Planning Commission Staff Report

SUBJECT: DR19-136, FLOWER CHILD

Approve two restaurant users within the San Tan Village area.

1 DRB EXTERIOR ELEVATION - NORTH
SCALE: 1/4" = 1' 0"

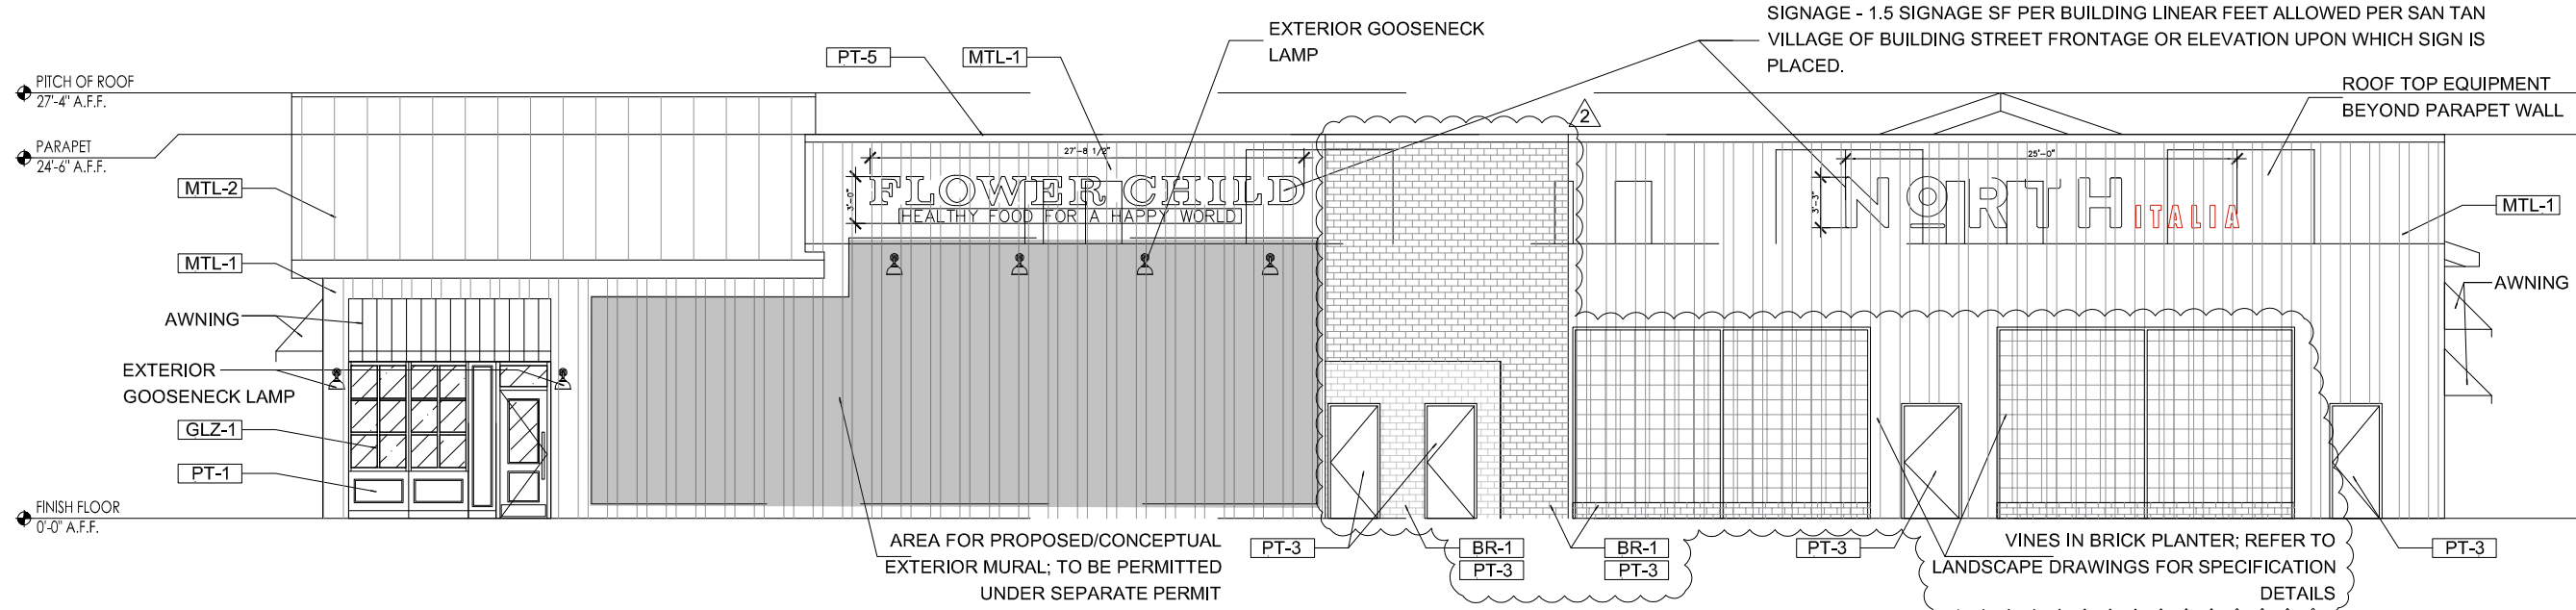
-Commissioners overall were pleased with the architectural theme of the building but felt the north and west elevations could use more articulation and further meet the Crossroad PAD requirements.

-The applicant has provided additional articulation to the west elevation by providing an additional row of window panes, a fabric awning over a utility door, and a black cap across the parapet. The north elevation will carry the black cap across the parapet and two large greenscreens have been added to further articulate the building. Brick has been added to the rear door area to provide an additional building material change and further accentuate the transition of the two restaurants as well as provide more movement to the building. The green screens are outlined with the same brick material at-grade. The gabled roofs at the main entrances have been expanded to further overhang from the building wall. Western red cedar wood has been added underneath the overhang to provide more depth and detail to the building while also capturing brown, a heavily used color within the SanTan Village area.
